GOVERNMENT OF THE DISTRICT OF COLUMBIA
DEPARTMENT OF TRANSPORTATION

MEMORANDUM

SUBJECT: ZC Case No. 17-14 – 500 Penn Street NE

This memorandum reviews the Applicant’s post-hearing submission (Exhibit 35). The table below reviews the Applicant’s responses to the three (3) unresolved conditions requested in DDOT’s report (Exhibit 29) but not resolved in the Applicant’s presentation at the June 14, 2018 Zoning Commission Hearing (Exhibit 32): retail parking pricing, off-site pedestrian improvements, and an access easement through the site for future use by the adjacent property.

Figure 1 Applicant-proposed Pedestrian Improvements (Exhibit 35D)

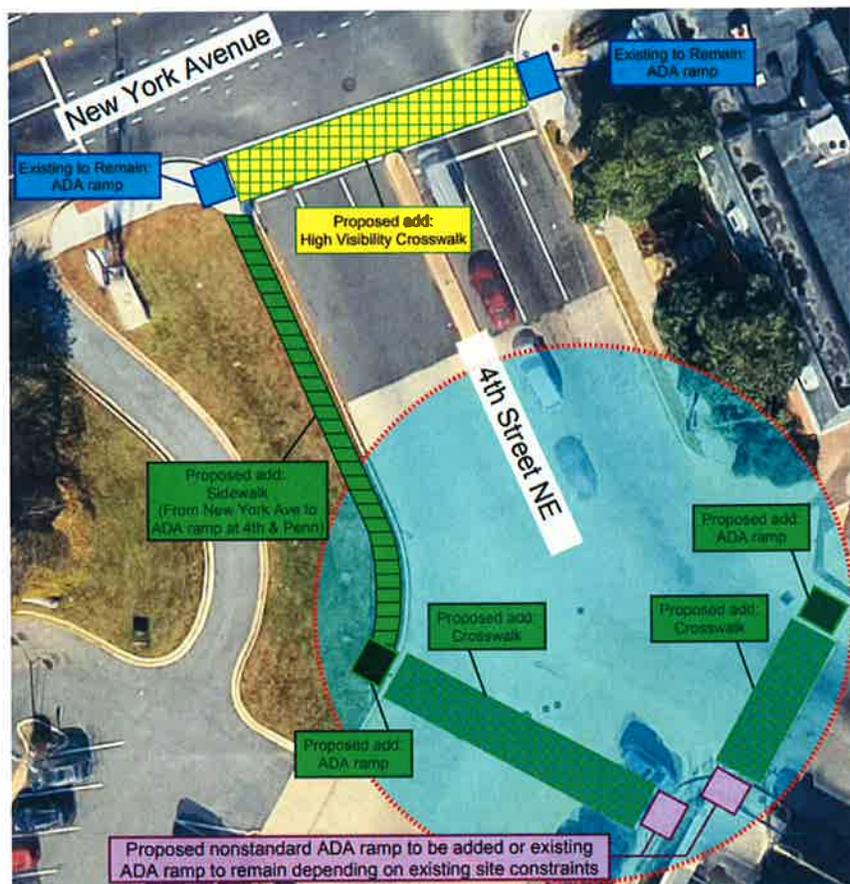
Condition	Applicant Response	DDOT Evaluation
Retail parking pricing	Applicant does not agree to charge market rate fees for retail parking because “an affordable parking scenario is critical to the success of this evolving retail.”	DDOT continues to find that charging market rate retail is important to encourage non-auto travel to the site and an important component of the mitigations package to address the nine (9) intersections impacted by the subject development.
Off-site pedestrian improvements	Applicant proposes the following pedestrian improvements as shown in Figure 1 (Exhibit 35D): <ul style="list-style-type: none">• Sidewalk on the west side of 4th Street from New York Avenue to Penn Street• Crosswalks at the northbound and westbound approaches of the 4th Street & Penn Street intersection	DDOT offers the following review of the proposed pedestrian improvements: <ul style="list-style-type: none">• At the Zoning Commission Hearing, the Applicant agreed to improve the sidewalk along the north side of Penn Street up to the western crosswalk at the 5th Street & Penn Street intersection, including curb ramps and a crosswalk across Penn Street. DDOT finds this acceptable.• The sidewalk on the west side of 4th Street is expected to meet DDOT standards, including six (6) feet wide with a four (4) foot tree box. Aside from being required to

<ul style="list-style-type: none"> • ADA-compliant curb ramps at the southwest and northeast corners of the 4th Street & Penn Street intersection • Non-standard ADA curb ramps at both movements of the southeast corner of the 4th Street & Penn Street intersection • High-visibility crosswalk along New York Avenue at 4th Street 	<p>meet DDOT standards, the tree box is needed to avoid an existing signal control box near the New York Avenue & 4th Street intersection.</p> <ul style="list-style-type: none"> • Curb ramps at the southeast corner of the 4th Street & Penn Street intersection must meet ADA requirements. DDOT reviewed the corner and finds that a blended transition can be installed in this location (2015 DDOT Standard Drawing 606.13), which would avoid potential conflicts with the stormwater inlet and fire hydrant and be significantly cheaper to install than a curb extension. DDOT has had additional coordination with the Applicant following the Post-Hearing Submission, and the Applicant is in agreement with installing a blended transition at this intersection. Given the constrained sidewalk space in this area, a minimum four (4) foot sidewalk should be provided in lieu of the six (6) sidewalk as shown in Standard Drawing 606.13. • DDOT also notes that as part of signalization of the 4th Street & Penn Street intersection, curb relocation work may be required in order to locate signal poles, which may alter the scope of work required at the intersection to implement the conditioned pedestrian improvements. <p>Exhibit 35D should be updated to address the comments above.</p>
